Memorandum

To/Attention	John Sevigny City of Ottawa	Date	July 20, 2022
From	Lance Erion	Project No	103291.5.3.1
cc			
Subject	RSDC Phase 15-1A Redevelopment of Block 196 Solarium Avenue

To/Attention	John Sevigny, City of Ottawa	Date	May 11, 2022
From	Mahsa Ghasri Terry Brule	Project No	103291- 5.2.2.1
cc	Marcel Denomme, Urbandale		
Subject	Assessment of Revised Block 196 Storm and Sanitary Servicing

Drawing Title
SANITARY DRAINAGE
 AREA PLAN

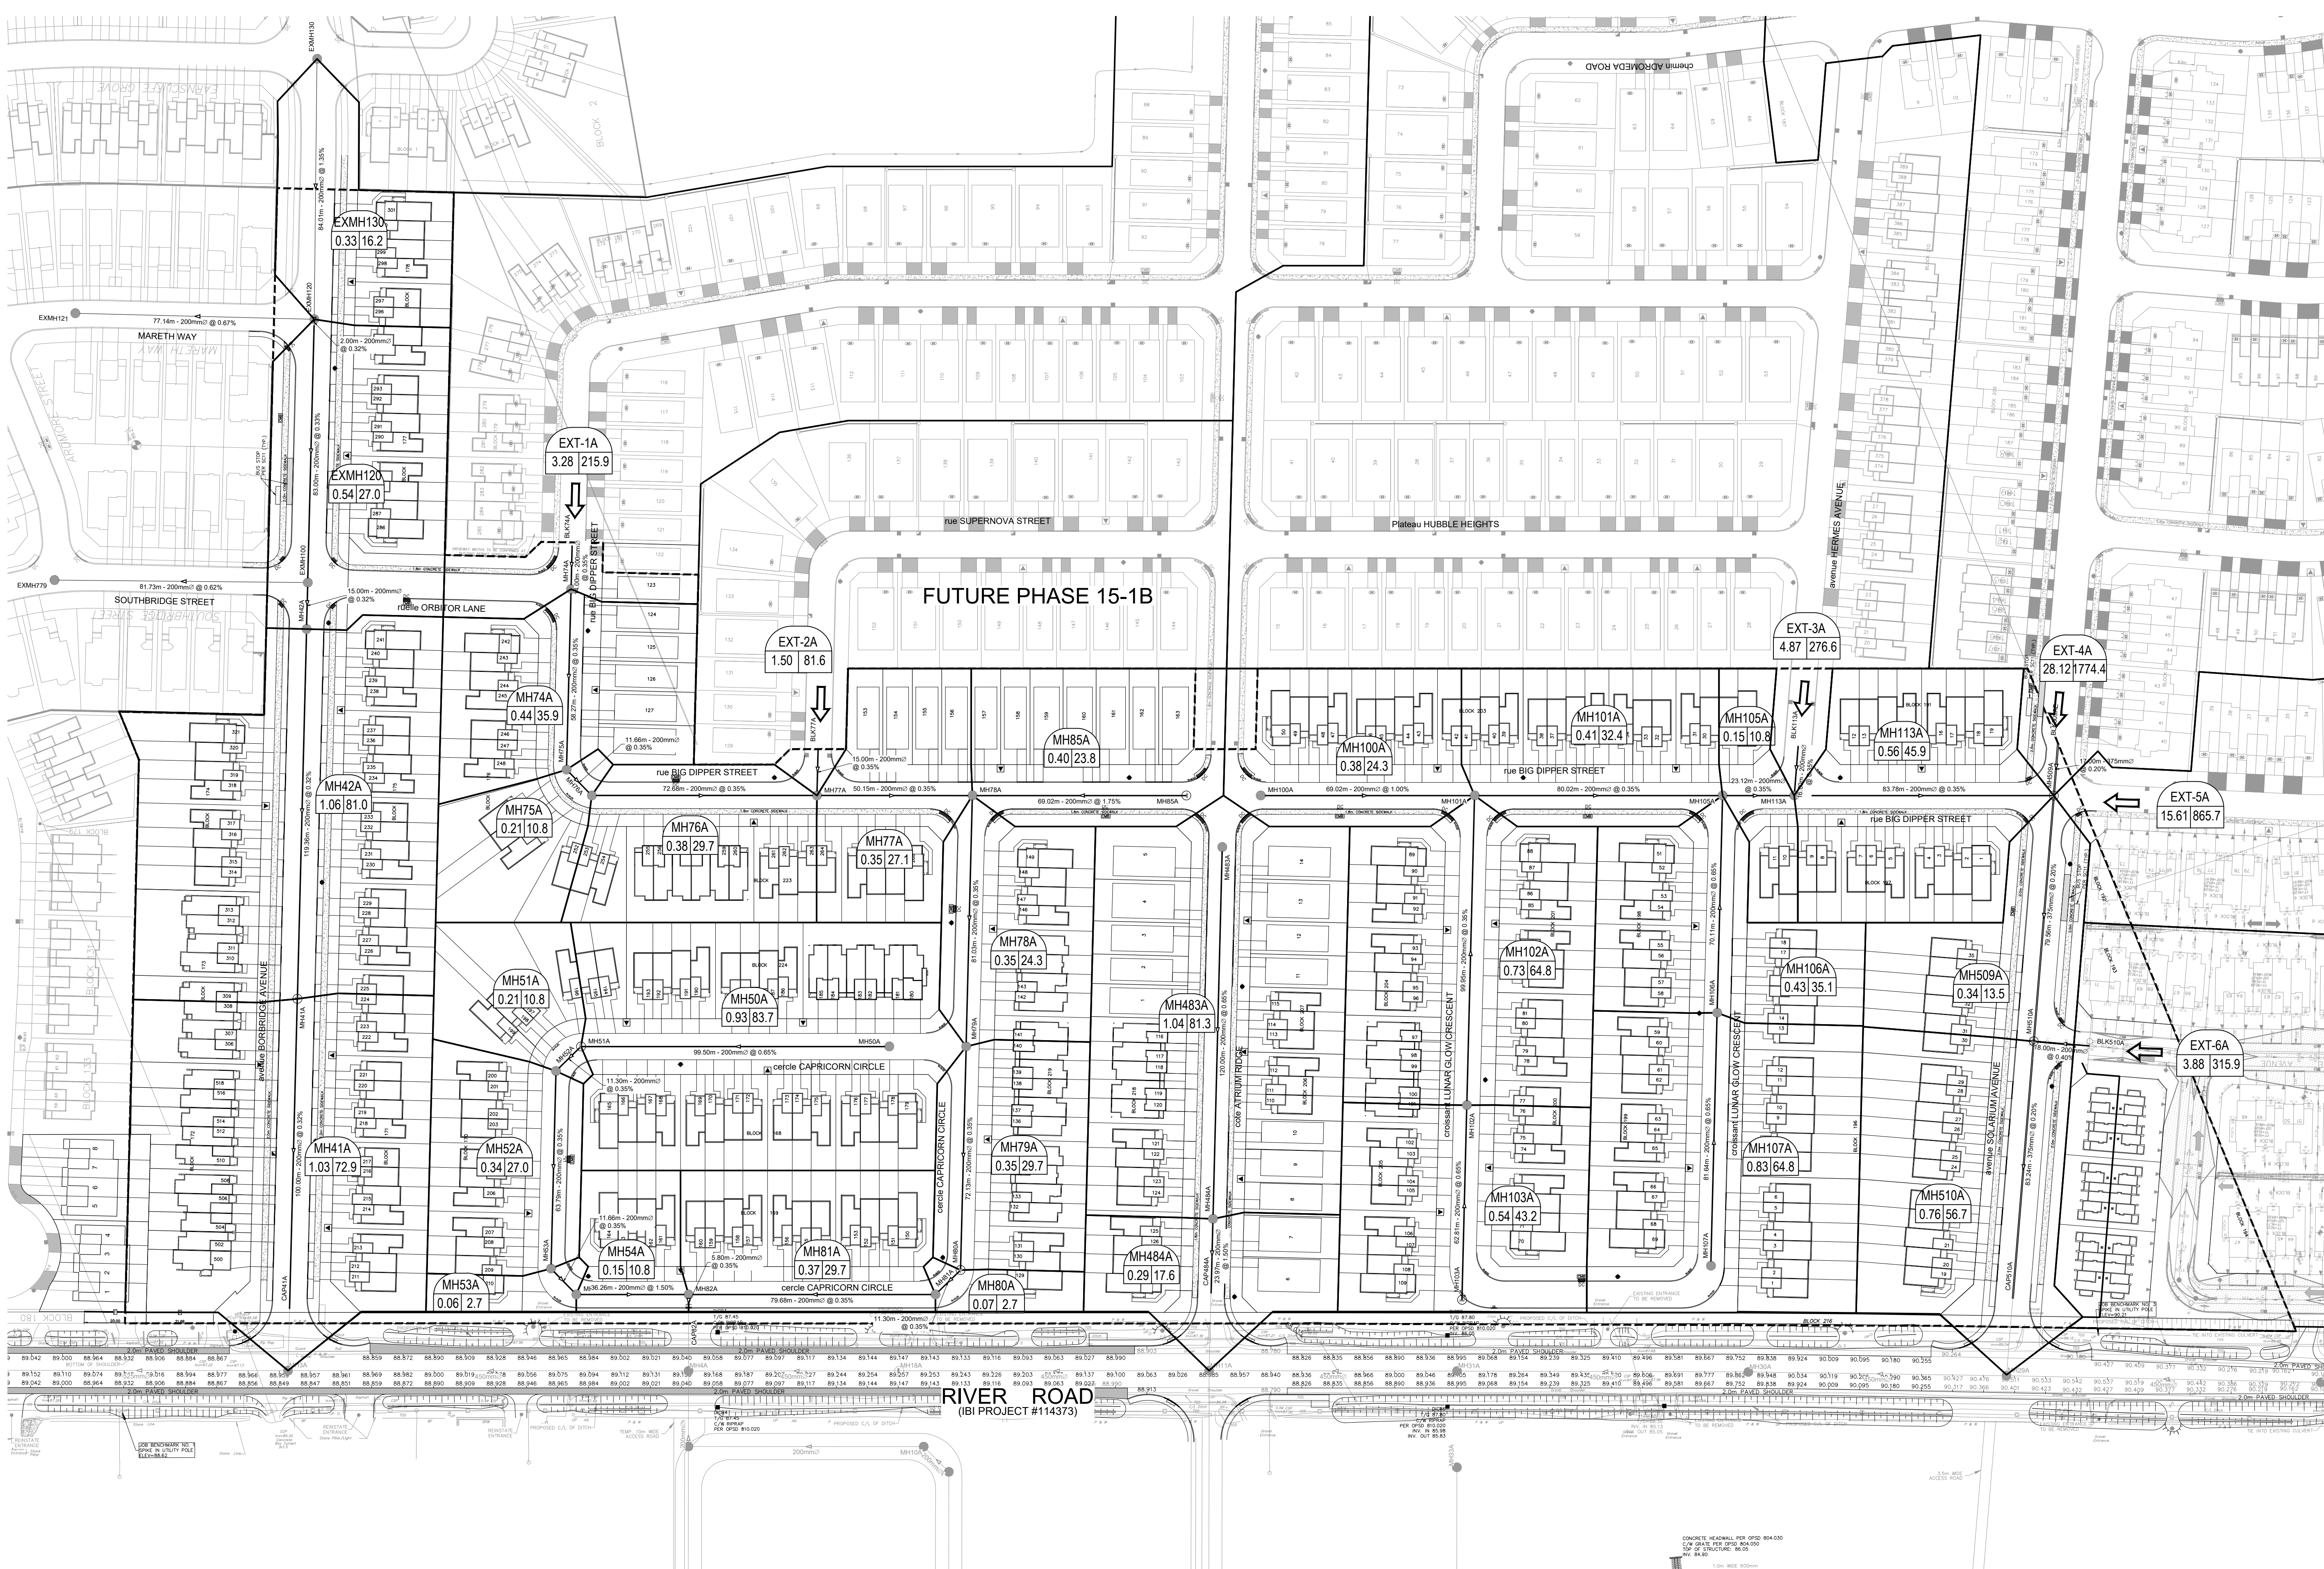
In the design brief Block 196 was tributary to the 375mm sanitary sewer on Solarium, the peak sanitary flow for the new townhouses is 0.62 l/s higher than the institutional flow. While there are new service connections on Lunar Glow Crescent the increase in flow is accommodated in the excess capacity of the Lunar Glow Crescent sanitary sewers and downstream sewers. Attached is the revised Sanitary Drainage Area Plan and updated Sanitary Sewer Design Sheet.

Drawing Title
STORM DRAINAGE
AREA PLAN

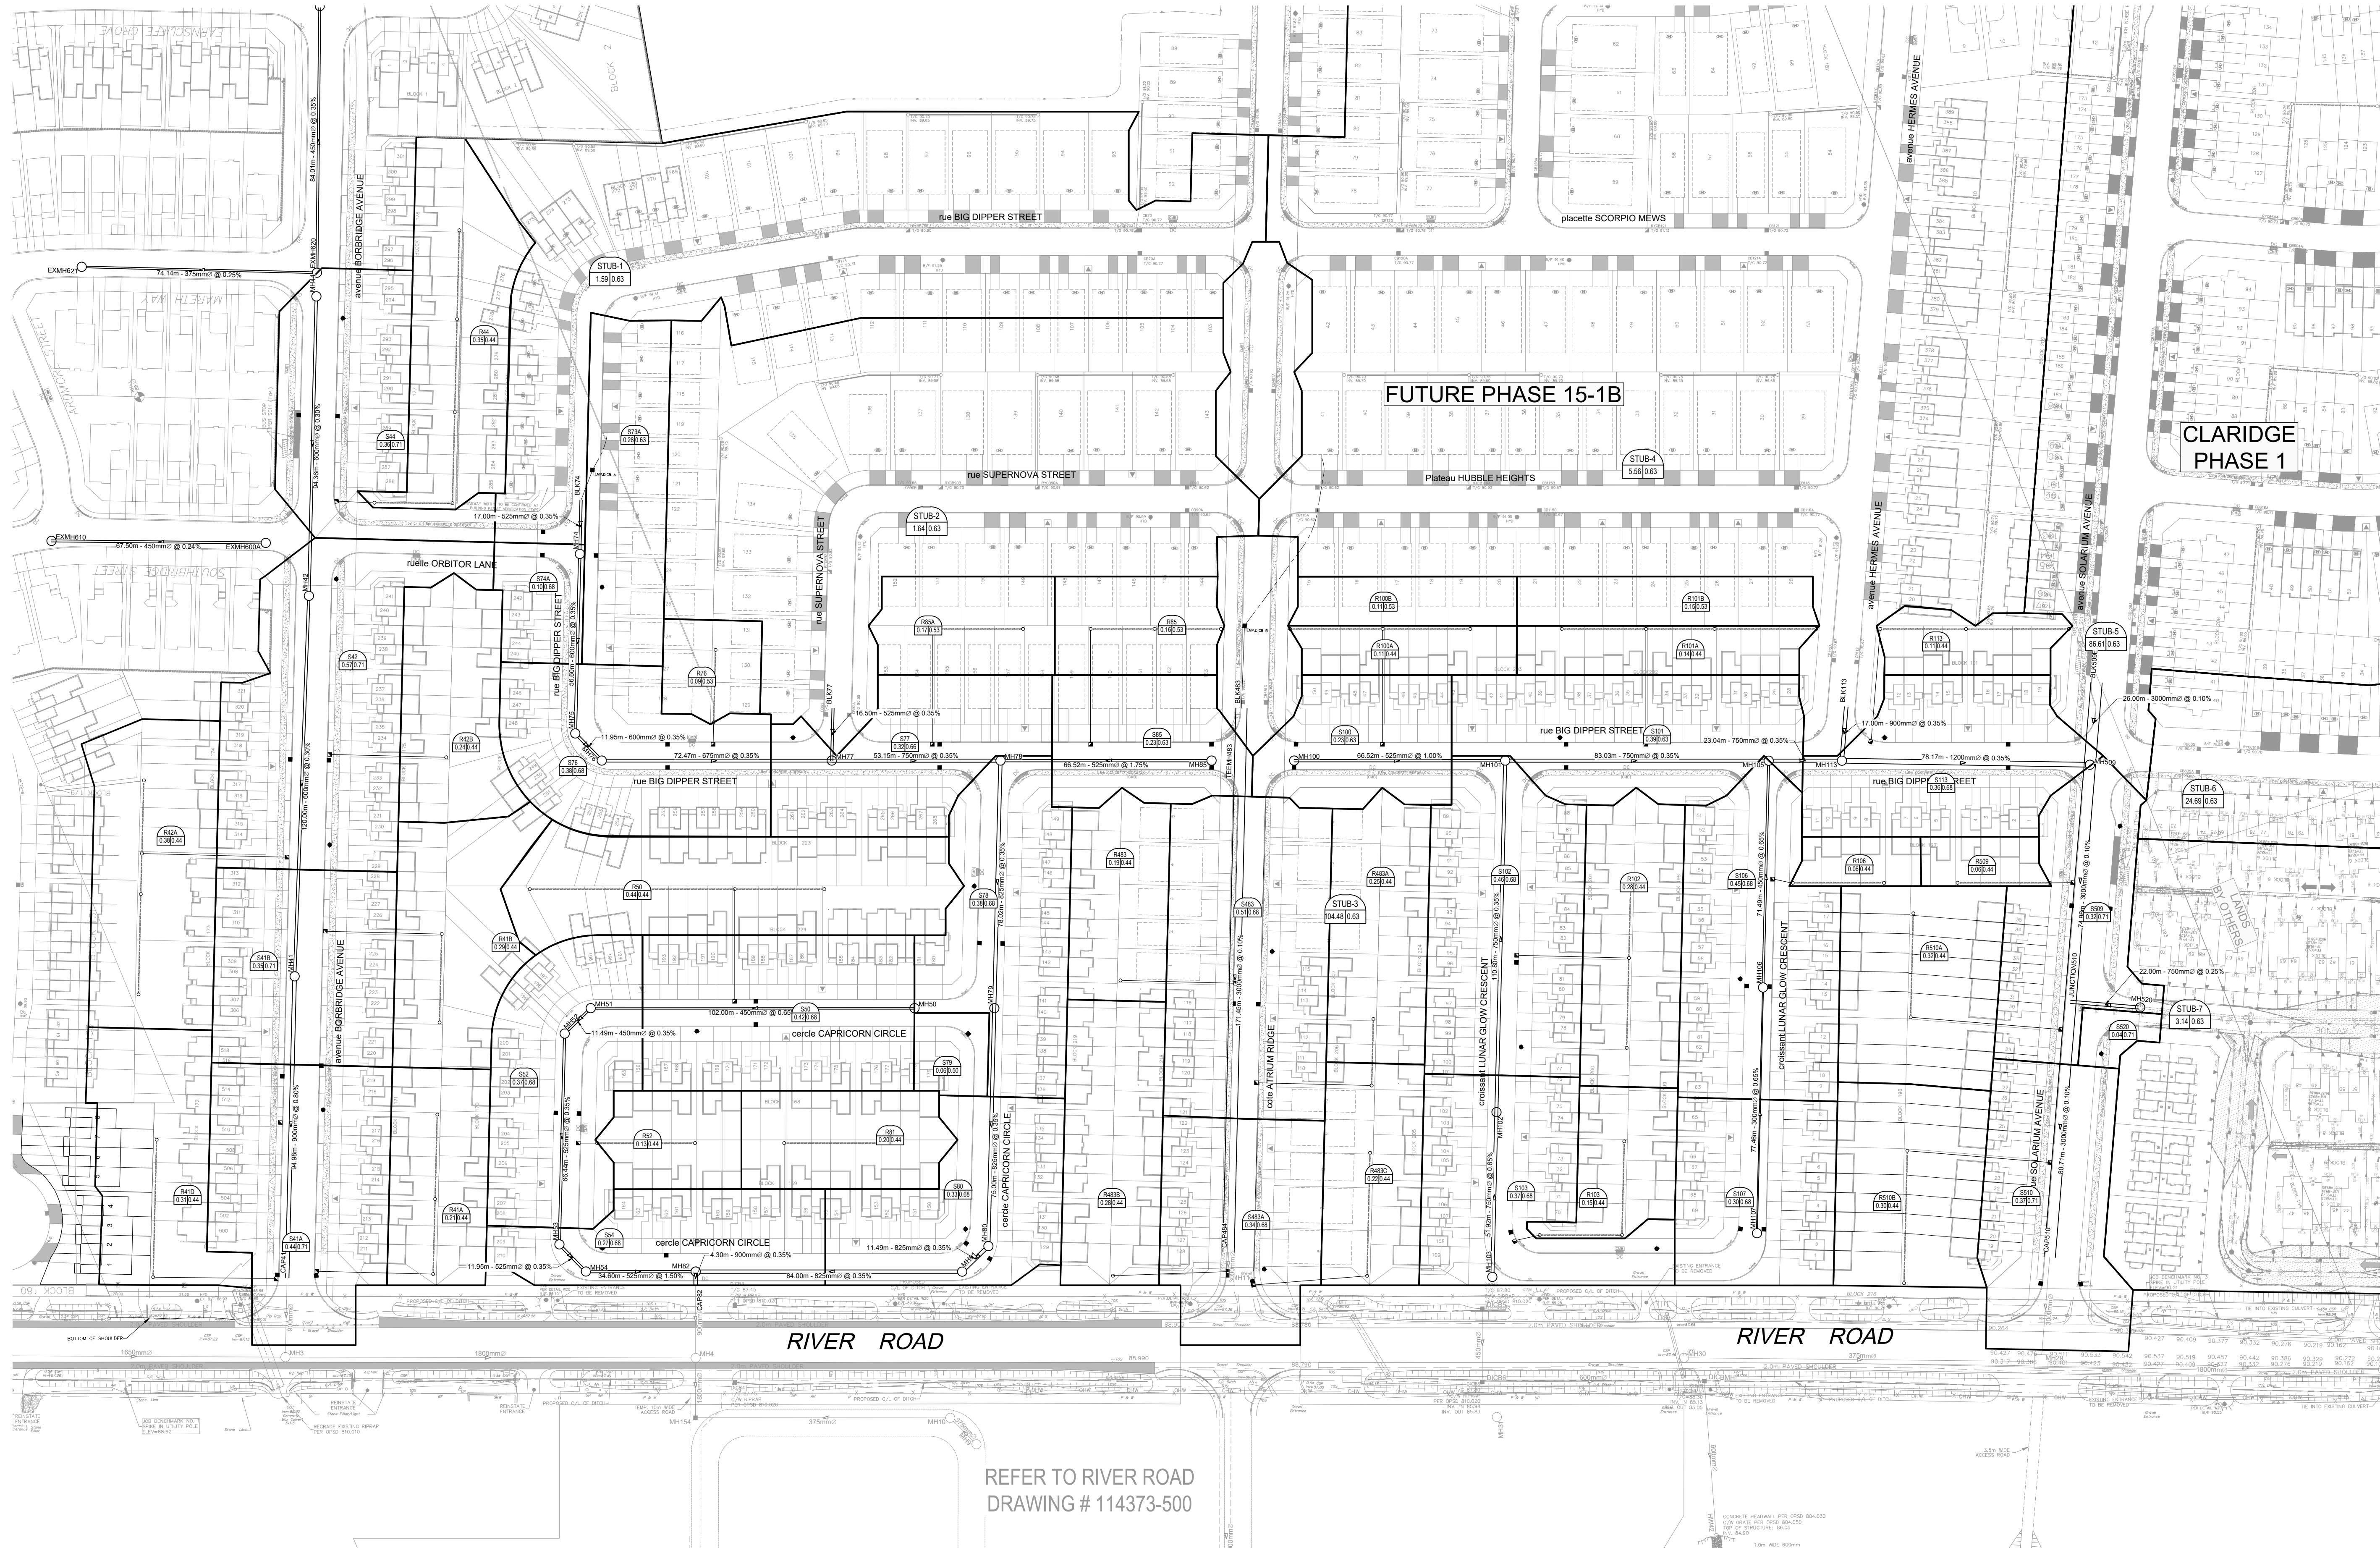
In the design brief Block 196 was tributary to the 3000 mm storm sewer on Solarium, the new design has the townhouses on Solarium and all of the rear yards draining to the Solarium storm sewer while the front half of the townhouses on Lunar Glow now drain to the streets storm sewers. The runoff coefficients for townhouses ($C=0.68$ front, $C=0.44$ rear) is less than the coefficient for institutional ($C=0.70$) so there is overall less storm runoff, while there is an increase in flow on Lunar Glow Crescent it is accommodated in the excess capacity of the Lunar Glow Crescent storm sewers and downstream sewers. Attached is the revised Storm Drainage Area Plan and updated Storm Sewer Design Sheets.
